Johns Creek

Board of Zoning Appeals Meeting
September 21, 2021

| CASE NUMBER: | V-21-008 |
| VARIANCE REQUEST: | Encroach into the 50-foot undisturbed buffer and 75-foot impervious surface setback to construct a new house and a pool |

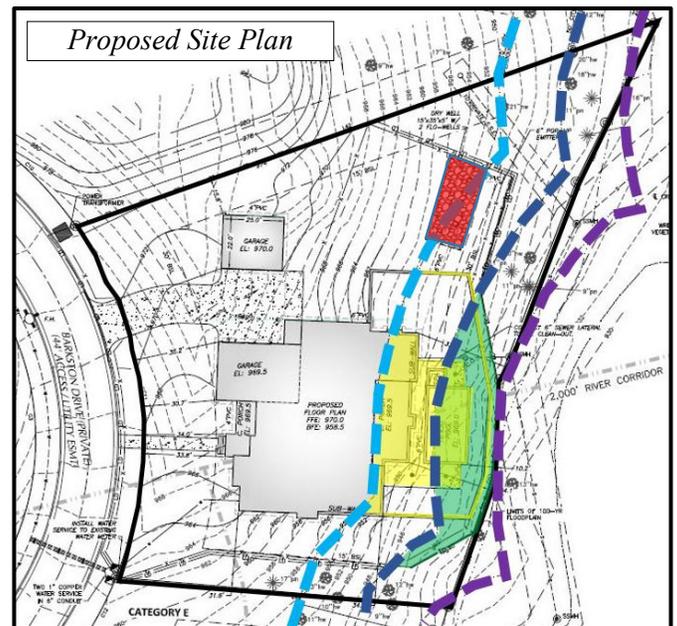
The Applicant is requesting a stream buffer variance to disturb 2,084 square feet (shown in green) in the 50-foot undisturbed buffer, and adding 2,336 square feet of impervious surface (in yellow) in the portion of the additional 25-foot impervious surface setback, to construct a new house and a pool. The Applicant has not proposed any land disturbance or impervious surface within the State's 25-foot stream buffer.

In order to offset the adverse impacts associated with the encroachment, the Applicant has proposed to install a dry well (in red) that would hold an additional 201 cubic feet of stormwater runoff.

The subject property was platted in 2019 without showing any stream buffers. However, a recent site visit confirmed the presence of wretched vegetation around the lake, requiring the 75-foot stream buffer to be applied to the rear of the property. The addition of the stream buffer would create a hardship for the homeowner, requiring them to apply for a variance. In order to mitigate the impact of encroachment into the stream buffer, the Applicant has proposed installing a dry well to capture an additional 201 cubic feet of stormwater runoff.

- 1) The proposed development shall not exceed the following encroachments, as shown on the site plan received by the Community Development Department on August 25, 2021:

- a. 2,084 square feet of disturbance within the 50-foot undisturbed stream buffer;
 - b. 2,336 square feet of impervious surface into the 75-foot impervious surface setback.

- 2) No land disturbance shall occur within the State 25-foot stream buffer.
- 3) A stream buffer mitigation plan shall be submitted to the Community Development Department, and approved by the City's Land Development Manager, prior to the issuance of a building permit. Said plan shall be consistent with the mitigation plan proposal received by the Community Development Department on August 27, 2021. The mitigation plan shall pass City inspection prior to the issuance of a Certificate of Occupancy.

- 4) Owner/Developer shall revise and re-record the final plat to reflect the 25-foot State undisturbed buffer, 50-foot City undisturbed stream buffer and additional 25-foot impervious surface setback on the property, prior to the issuance of a Certificate of Occupancy
